Technical Memorandum Review of Water Supply Assessment Village at Squaw Valley

July 13, 2015

Prepared for: Sierra Watch
Prepared by: Tom Myers PhD
Hydrologic Consultant, Reno NV

Figure 3: Screen capture of Squaw Valley model layer 1 and cross-section along column 17

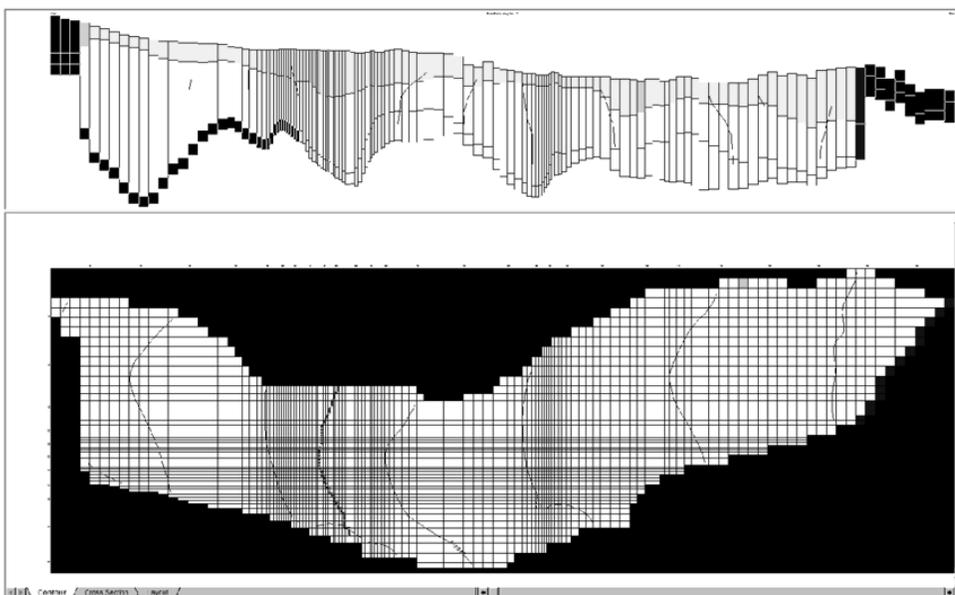
Drain cells in yellow cover most of layer 1. The head in these Drain cells equals the ground surface and conductance is very high. When the groundwater table reaches the ground surface, the Drain boundary removes it from the model domain. These cells are apparently designed to prevent the water level in the aquifer from extending above the ground surface, in an effort to simulate rejected recharge (West-Yost 2003). The Drain cells remove about half of the recharge in the current model.

The dark blue boundary on the far east is a constant head boundary for flow through the moraine bounding the east end of the valley. During the calibration run, the discharge through this end in the model is about 660 af/y. The conceptual model estimate for flow through the moraine was 220 af/y (Williams 2001). In 2003 the simulated flow across the moraine for model calibration was 83 af/y. The boundary was originally applied only in layers 2 and 3 (West-Yost 2003, Williams 2001), now is in layer 1. I found no description of why layer 1 was added but it may have been necessary to accommodate the much larger recharge running through the current model as compared to the earlier model.

Groundwater contours show a steep water table near the mountain front on the western third of the model (Figure 3). Groundwater would flow perpendicular to the contours, directly toward the center of the model domain and the green stream boundary. This steepness would require substantially lower conductivity in that area, but the K in this area (Hundt and Williams 2014, Figure 6) is over 200 ft/d in some areas. The steep contours are not observed in layer 2 (Figure 4). The thinness of layer 1 near the edge, as can be seen in the cross-section (Figure 3), probably reduces the transmissivity which requires the steep gradient. Layer 2 is no flow, and the groundwater contour in layer 1 is actually lower than the bottom of the layer. This probably does not cause a problem with the overall simulation results, but it does suggest localized water balance issues in the west end of the model.

Figure 4: Screen capture of Squaw Valley model layer 2 and profile along row 17.

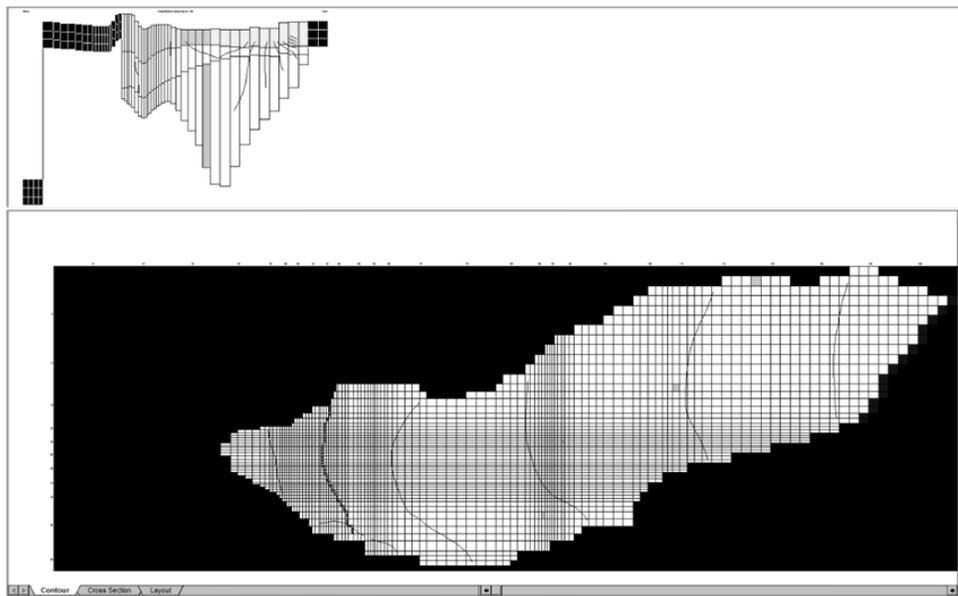
Figure 4 shows the plan for layer 2 and a longitudinal profile along row #17. The dark blue boundary on the east is the constant head boundary as discussed for layer 1. There is also one cell of stream boundary in the in the middle toward the bottom (south) of the layer. It lies adjacent to the boundary cells in layer 1, and has flows similar to that stream reach, so it is probably part of that stream reach. The figure also shows one GHB cell in the north boundary on the east. Flow through GHB cells are minor and this boundary is probably irrelevant. The cross section shows the changes in thickness of the alluvial aquifer varies substantially. The aquifer thickness would help control the location that water enters and leaves the stream by constricting the thickness of the alluvium and the area of the cross-section through which the groundwater flows. The area just west of the meadow where groundwater levels become higher and intersect with the stream bottom corresponds with the west end of the thinner section just west of the middle of the cross-section (Figure 4).

The purple line about a third of the distance east from the west boundary is a fault, or slurry wall as modeled in GWVistas™ as 1 foot thick with $K=0.3603$ ft/d, which is not very impermeable but is significantly less conductive than the K values in the model cells around, which are generally greater than 14 ft/d and range to greater than 200 ft/d. The fault appears in all three layers. It apparently flattens the groundwater table west of the fault and causes a several foot step to lower levels east of the fault.

Figure 5: Screen capture of Squaw Valley model layer 3 and cross-section along column 109.

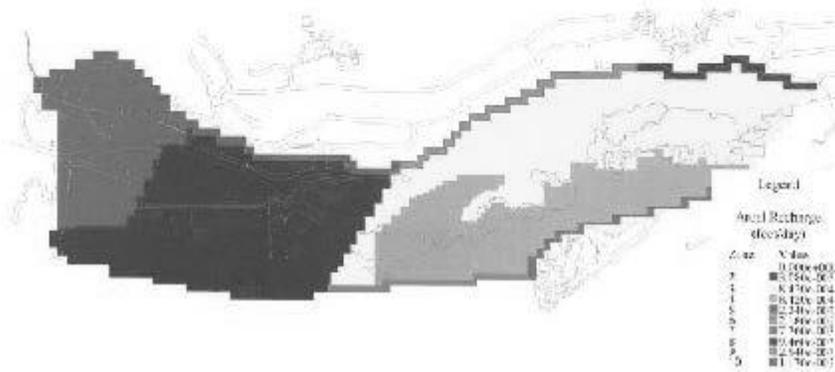
Layer 3 does not extend as far to the west (Figure 5) as does the layer 1 and 2 model domain (Figures 3 and 4). Hundt and Williams (2014) Figure 1 shows the bottom elevation of layer 2 in the west is approximately the same as layer 3 just to the east. The profile in Figure 4 shows that layer 3 pinches to west but the aquifer thickness undulates but averages the same as further east. This western area is the

location of many of the pumping wells, so this domain configuration would require that most wells pump from just layer 2. Pumping may be more efficient this way because water would not have to flow between layers which would be limited by the vertical anisotropy; this could minimize the drawdown caused by the wells. Now that the model uses MNW routine for wells, the pumping can be as efficient from two as from one layer so the model should have layer 3 extend as far west as layer 2 to better account for differing vertical conductivity.

Groundwater contours in the cross-section at column 109 suggest a vertical circulation from layer 1 near the boundary through layer 3 and back to discharge to the stream in layer 1 (Figure 5).

Figure 7: Hundt and Williams (2014) recharge zones.

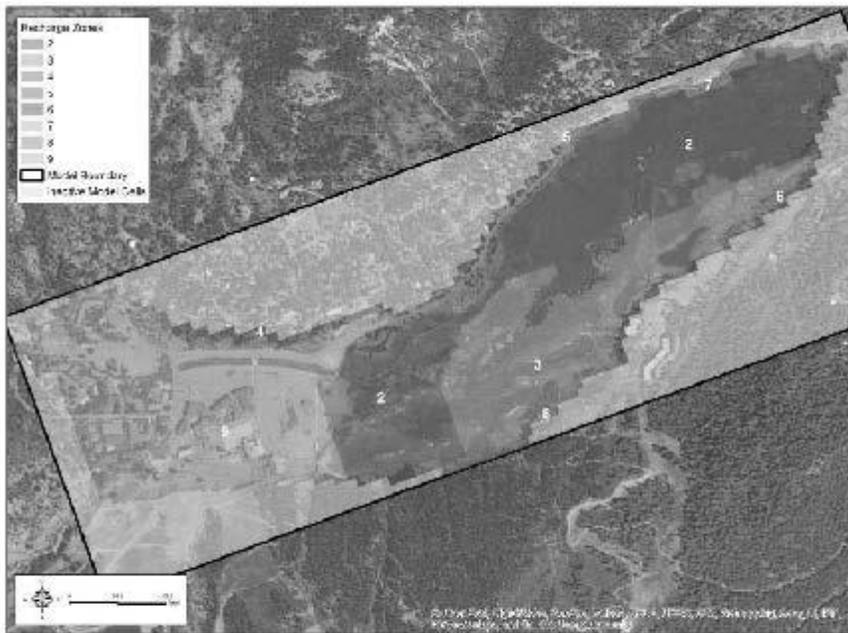
Figure 6 shows how Williams defined recharge zones and Figure 7 shows the most recent (Hundt and Williams 2014) variation. Recharge zones are specified flux boundaries, meaning the modeler specifies the rate in length/time. Williams (2001) apparently set constant values (Figure 6) meaning that water entered the model distributed evenly over the area of the zone. Recharge as applied to the model apparently includes many sources of water, including distributed recharge from precipitation on the spot, irrigation, leaks from sewer pipes, and others. Currently, recharge is estimated as a percent of monthly precipitation as discussed below. Zone 9 (Figure 7) covers the current development which means the model assumes recharge through the parking lots, which is impossible. The differing zones along the edges of the domain suggests simulation of mountain front recharge.

Figure 8: Recharge to model zone 9 for the first two years of the baseline simulation, converted to in/day.

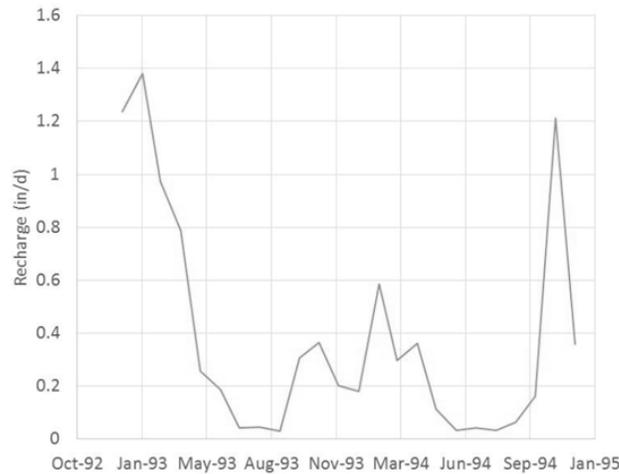
Figure 3 in Hundt and Williams (2014) show precipitation and delayed infiltration in inches (presumably per month) but is unclear whether each value is actual recharge or precipitation. I plotted two years of recharge from the model files for recharge zone 9 (Figure 7); the values the model tries to input into the aquifer exceed an inch per day during winter months (Jan-93) and also during Oct-94, a month during which all precipitation is available for recharge.

Figure 9: Recharge to the model domain, by month, for the calibration run from 1993 to 2011.

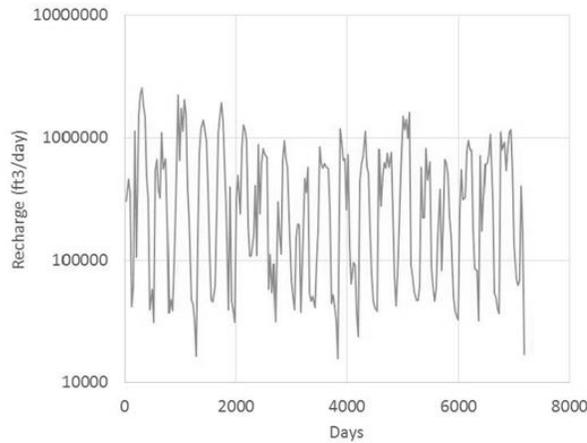
Figure 8 shows the monthly recharge variation as simulated from 1993 through 2011 by month in the calibration model. Some months there is barely any recharge, with values less than 20,000 ft³/day, and other months more than 3,000,000 ft³/day (Figure 9). The currently estimated recharge converts to about 3900 af/y, which is much larger than that used in the first editions of the model, which were 688 af/y (West-Yost 2003, Williams 2001). The current recharge amount is a gross overestimate due to the gross overestimate of precipitation.

Figure 11: Figure 13 from Hundt and Williams (2014) showing vertical anisotropy, or the ratio of horizontal to vertical conductivity.

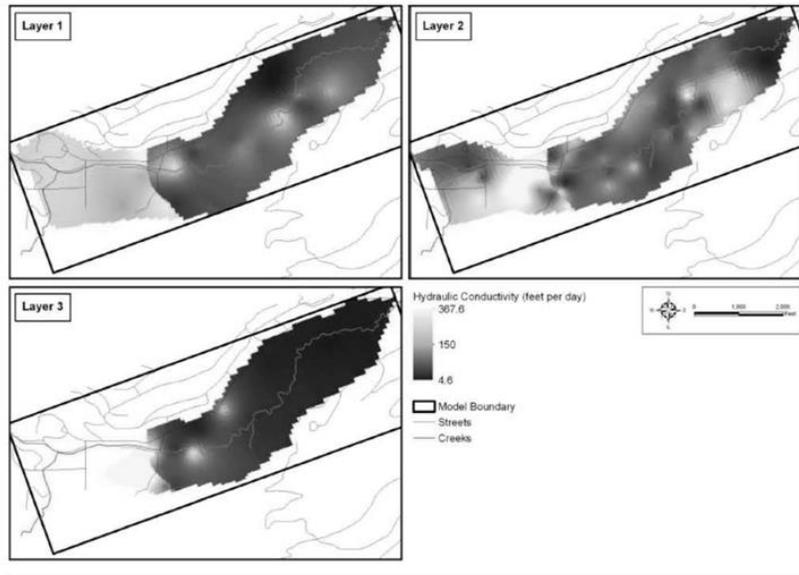
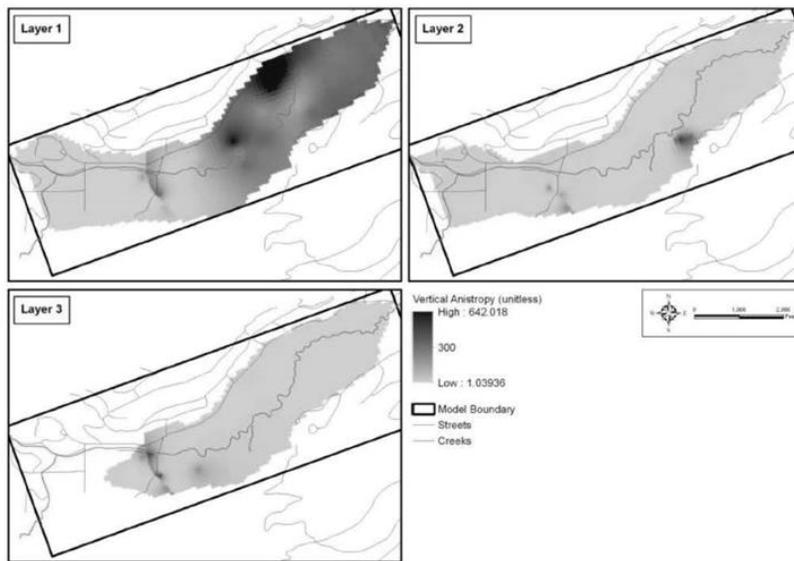
Hundt and Williams (2014) estimated conductivity using pilot points, a method which essentially establishes parameter fields across the model domain. The methodology needs more description than provided in the report (Hundt and Williams 2014, p 11). The number of wells used for calibration does not seem to be sufficient to create up to 78 pilot points per layer for calibration (Id.). The resulting parameter fields do not resemble hydrogeologic patterns, however, as can be seen on the circular patterns shown on Figures 10 and 11. Figure 10 shows circular areas with horizontal conductivity exceeding 100 ft/d in the middle of areas with conductivity much less than 100 ft/d. Vertical anisotropy has fewer circular zones, but those that occur in layers 2 and 3 are areas where the model will simulate very little vertical flow. It is also very unusual to have the very high anisotropy in surface layers (layer 1 in Figure 11) because surface formations tend to be sorted rather than exhibiting continuous layers.

Figure 12: Hydrograph of model fluxes for the calibration model run. This figure shows the larger fluxes; see Figure 13 for the smaller fluxes.

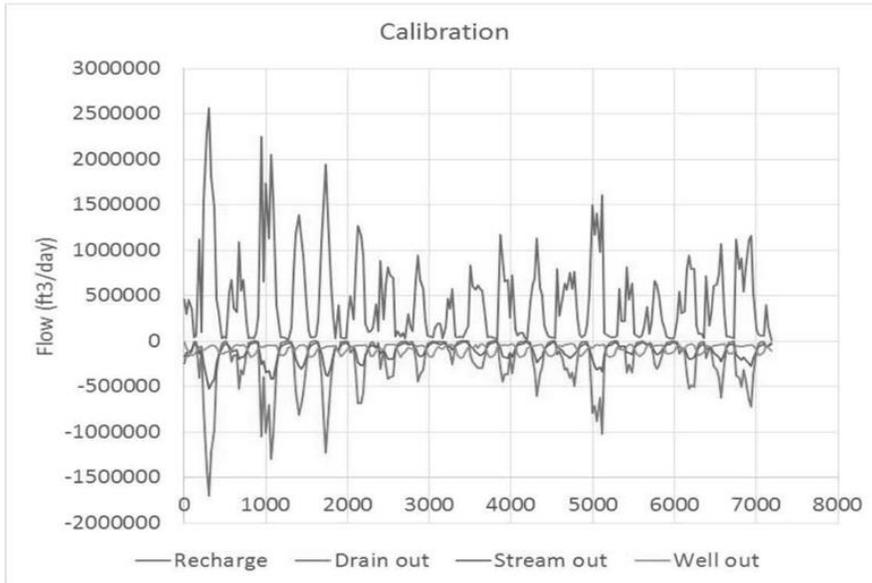
Water balance hydrographs for all fluxes were downloaded from the provided output files for each of the runs – calibration, baseline, and WSA. Recharge, drain outflow, well outflow, stream outflow, and CH out (constant head outflow) were the largest fluxes for the three scenarios (Table 1, Figure 12). The recharge, about 3900 af/y, is much larger than that used in the first editions of the model, which had been estimated at 688 af/y (West-Yost 2003, Williams 2001), probably due to the overestimated precipitation.

figure; most Drain flux occurs during wet years or months (Figure 12) and observations of the locations on the GWVistas™ screen show that most Drain flux occurs very near the stream in the west and over much of the meadow in the east. During dry periods Drain flux occurs east in the meadow if at all. Because the Drain boundary is set equal to the ground surface elevation, the water table at these discharging cells is slightly above ground surface.

Recharge controls the discharge to the Drains and to the streams (Figure 12). The observed pumpage during the calibration run was a small proportion of the recharge, much less than 20%. If recharge were still estimated as it was in 2003, the calibration pumpage would be very close to the recharge. The overestimate of recharge effectively controls the large amount of discharge to the streams and to the drains.

Figure 13: Hydrograph of model fluxes for the calibration model run. This figure shows the smaller fluxes; see Figure 12 for the larger fluxes

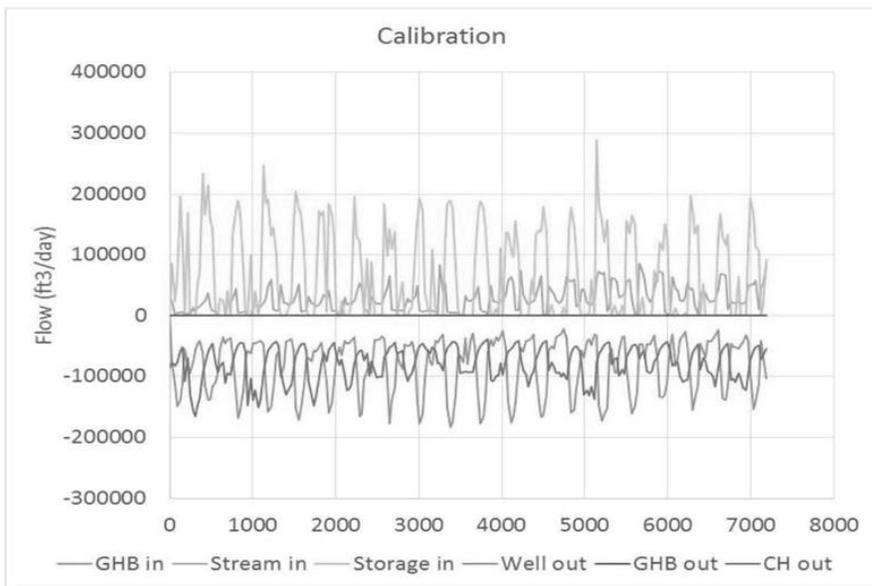
Small fluxes include GHB in, Stream in, and GHB out, at 3, 229, and 0.4 af/y (Figure 13). The GHB flux is not important, which reflects the fact that fractured bedrock flow is not a significant part of the water balance (Moran 2013). Stream in is less than a third of the Stream out value, which means the model simulates much more flow to the stream than from the stream, and the streams in the model provide only a small amount of recharge from the stream. However, as noted above, increasing pumpage does induce flow from the stream to the model domain.

Figure 14: Hydrograph of model pumpage for the three scenarios.

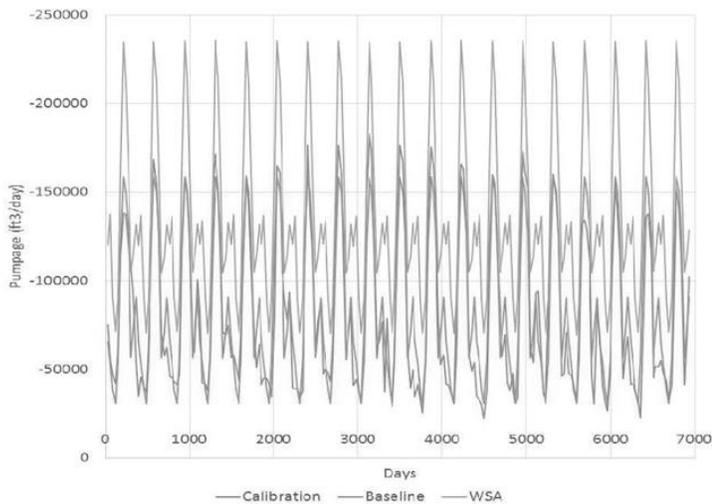
Well out for baseline is close to observed pumping from 1993 through 2011, not including water sources from the horizontal bedrock wells (Table 1, Figure 12). It is similar to the well pumpage for the calibration run except the observed pumpage for calibration is more variable (Figure 14). Pumpage for the WSA is close to the anticipated 2040 demand and is almost the same from year to year (Figure 14). The difference between Well out for Baseline and for WSA is the pumpage expected for the project, or about 427 af/y in the model (Table 1, fifth column).

Figure 16: Streamflow along the stream boundary for conditions in October 2011 for the calibration run.

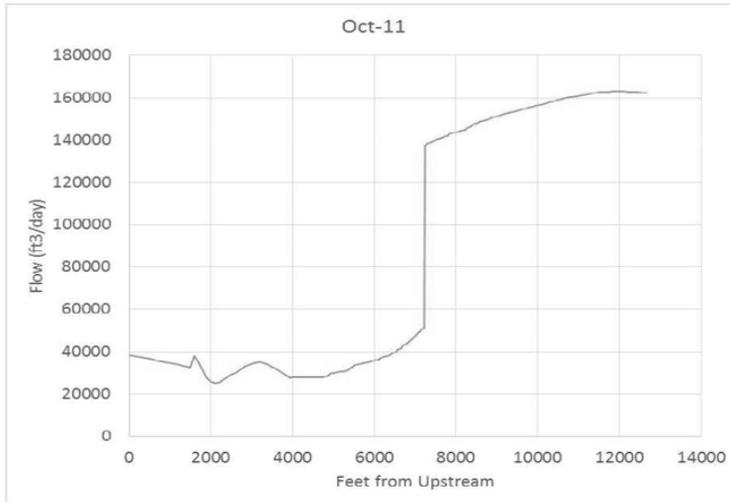
Figures 16 and 17 show examples of inflow and cumulative streamflow to the stream for periods during which the upstream inflow is vastly different (less than 40,000 ft³/d for Oct, 2011 (Figure 16) and greater than 3,000,000 ft³/d during June, 1994 (Figure 17))¹. The steps in the graphs reflect the two confluences in the stream boundary (Figure 3). During the drier period, little flow added to the stream from the south at the upstream most confluence (Figure 16). For the upper 5000 feet, the stream generally lost flow, from about 40,000 to 30,000 ft³/day. From about 5000 to 7200 feet, or about the eastern confluence (which is in the meadow), about 20,000 ft³/d discharge to the stream. A step of almost 80,000 ft³/d added to the stream at the confluence. Below that it increased relatively steadily about another 20,000 ft³/d. The flow magnitude is much higher in the wetter period (Figure 17), so small changes are difficult to see. Groundwater discharged to the reach through the domain but the main changes were at the confluence. During the wetter period, flow almost doubled at the upper confluence which reflects the large surface water flow simulated to enter the model domain. The stream trended up about 200,000 ft³/d between confluences and then stepped up about 100,000 ft³/d

¹ The graphs in Figures 16 and 17 have been adjusted to accommodate a model coding error. The model input files did not show stream segment 3 as a tributary to segment 10. This error applies only for the calibration files because there is no stream segment 10 in the baseline and WSA runs.
